CHANGE ORDER NUMBER: 3

Project # 10WC812

**CR 104 – Phase II
Williamson County Project No. 10WC812**

Change Order No. 3

WILLIAMSON COUNTY
 COUNTY ROAD 104
**SUMMARY OF
 DRAINAGE QUANTITIES**

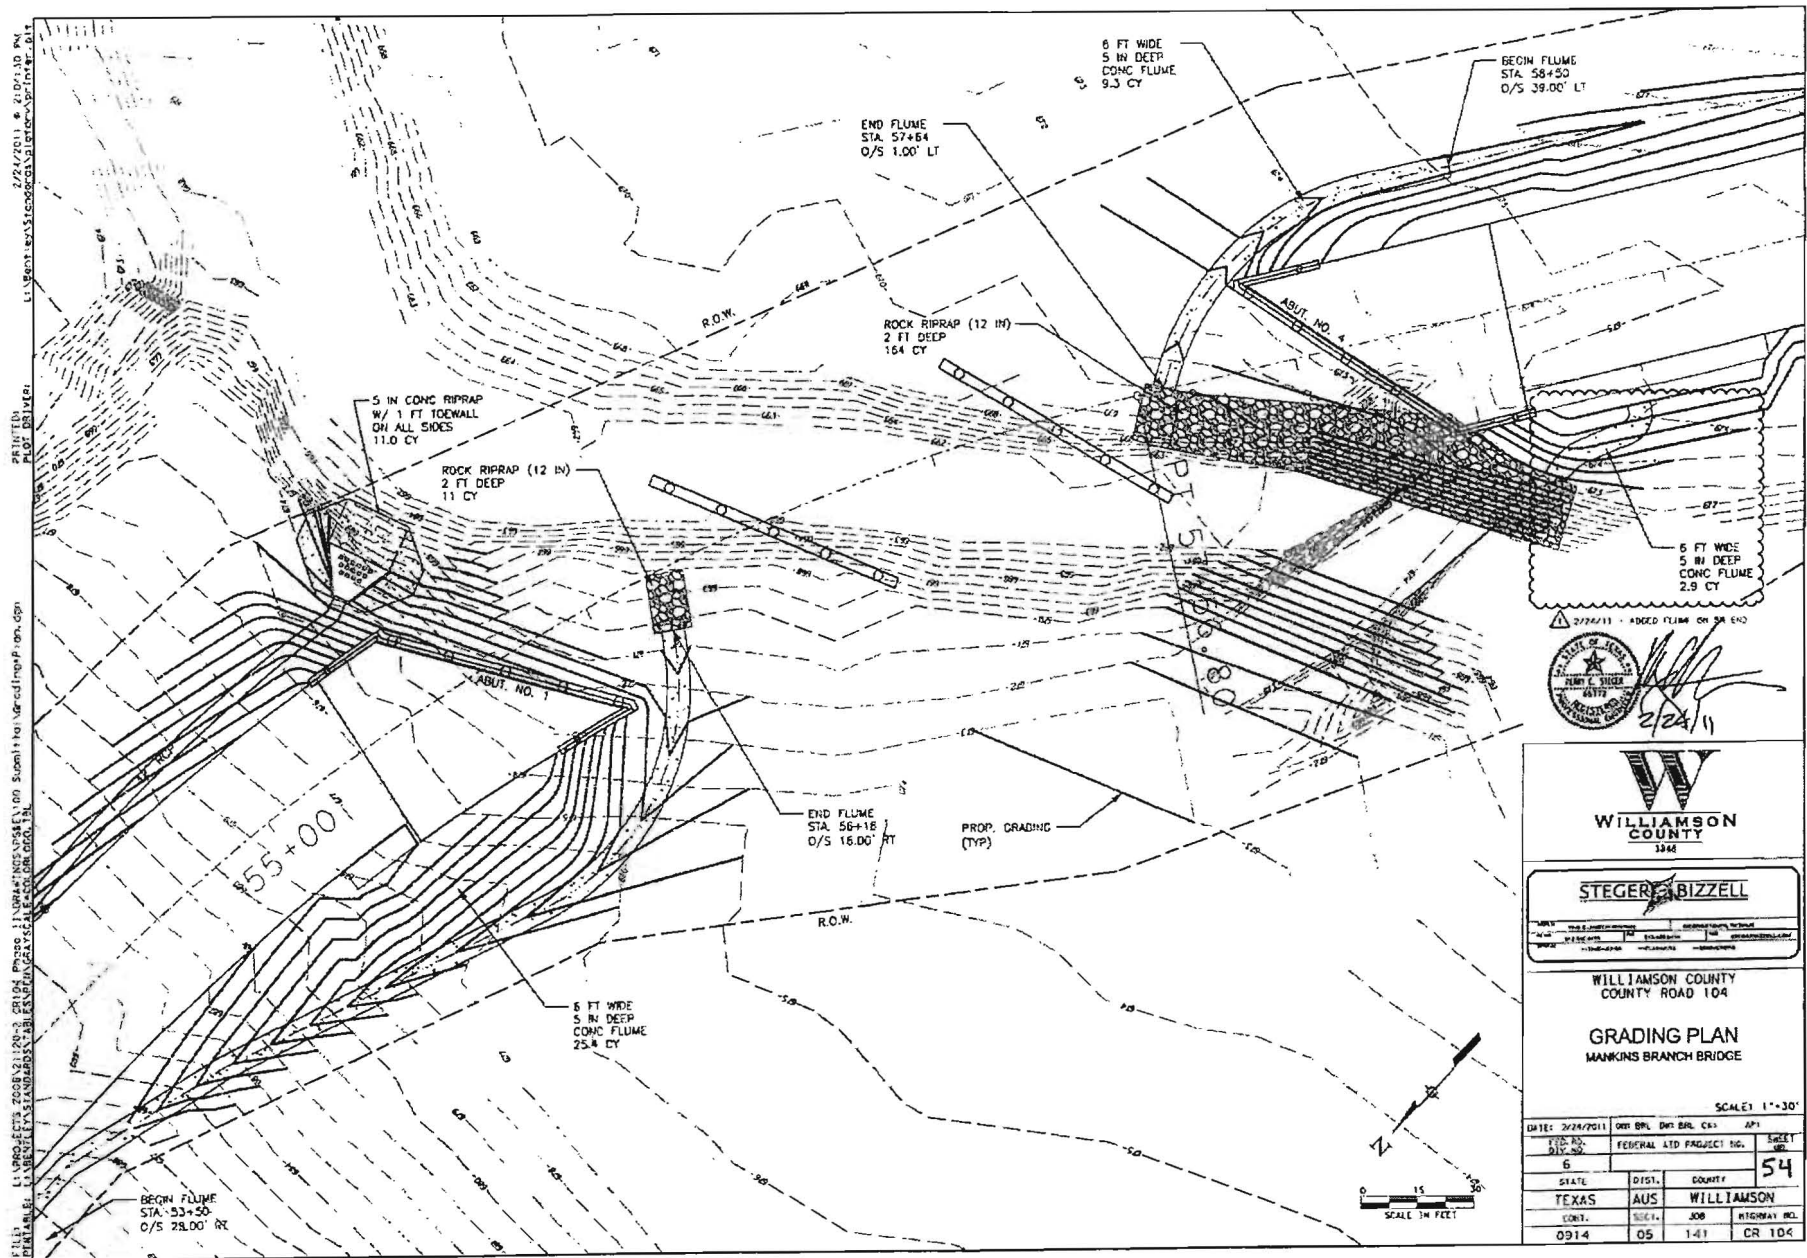
- 11/24/10 - STORM SEWER REDESIGN
- 12/23/10 - ADDED INLET #10
- 2/24/11 - ADDED CONC FLUME

GRADING PLAN
MANKINS BRANCH BRIDGE

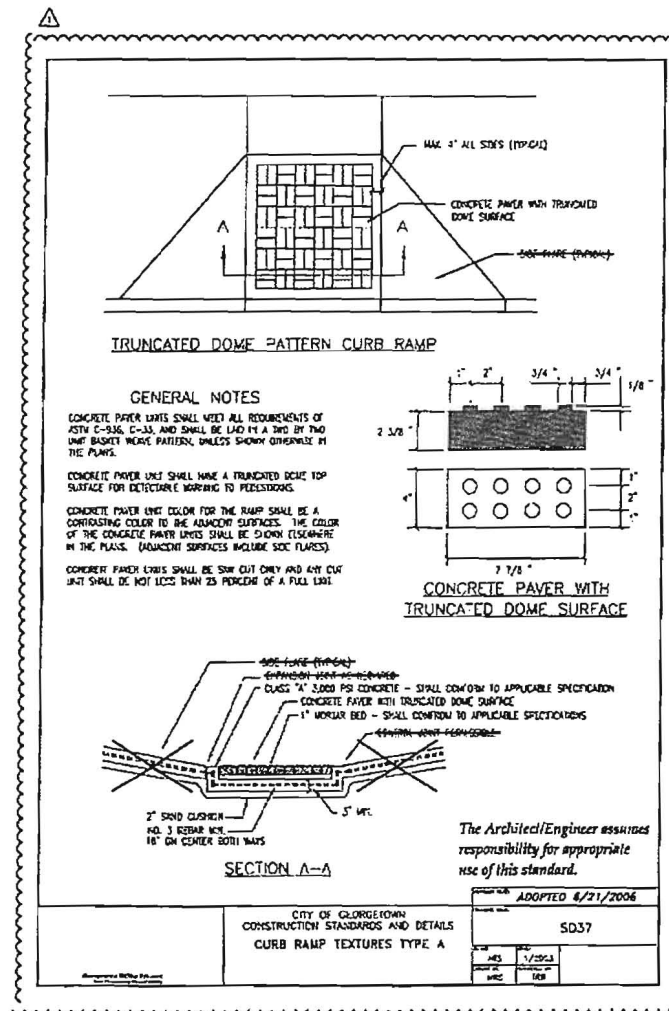
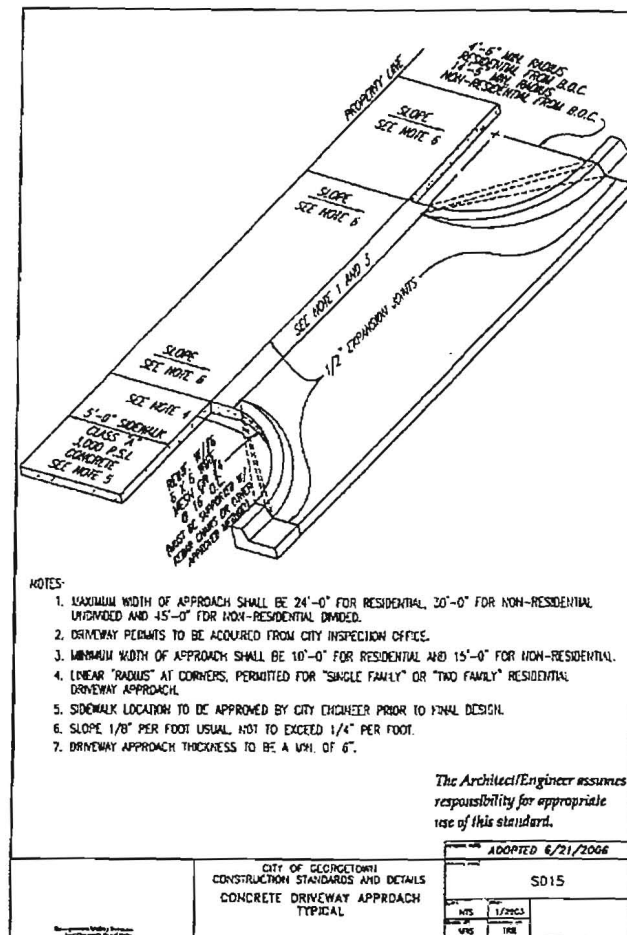
2/24/11 - ADDED FLUME ON SR END

CITY OF GEORGETOWN
ROADWAY STANDARDS

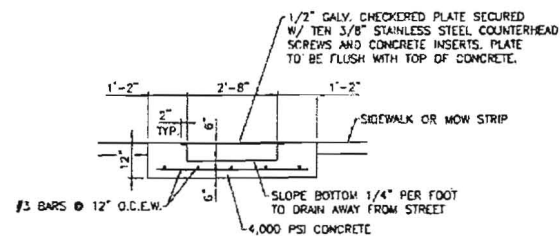
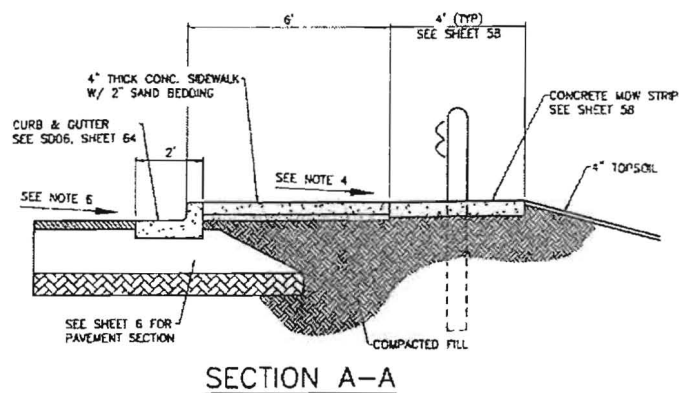
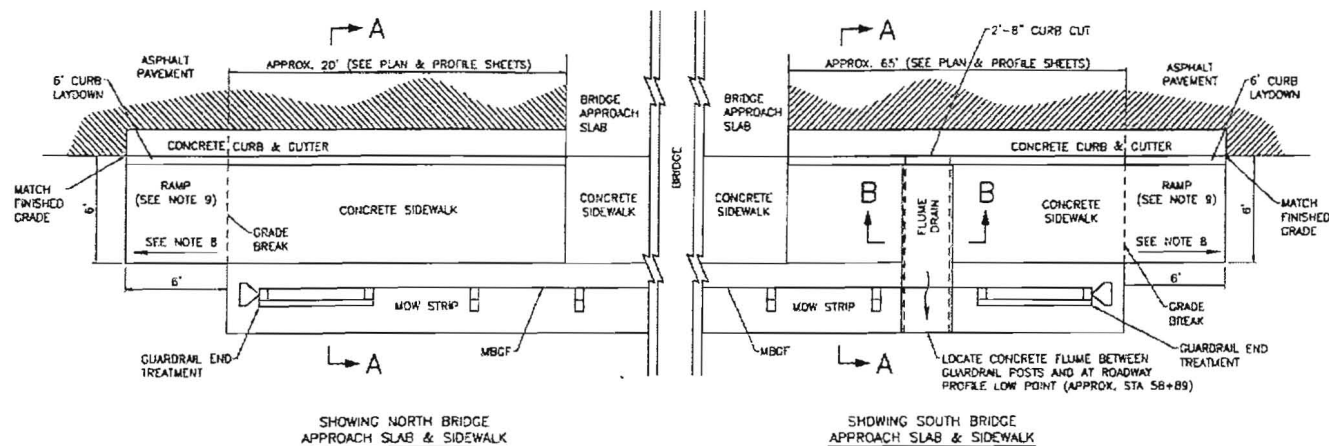
2/24/11 - ADDED SIDEWALK TEXTURE (5037)
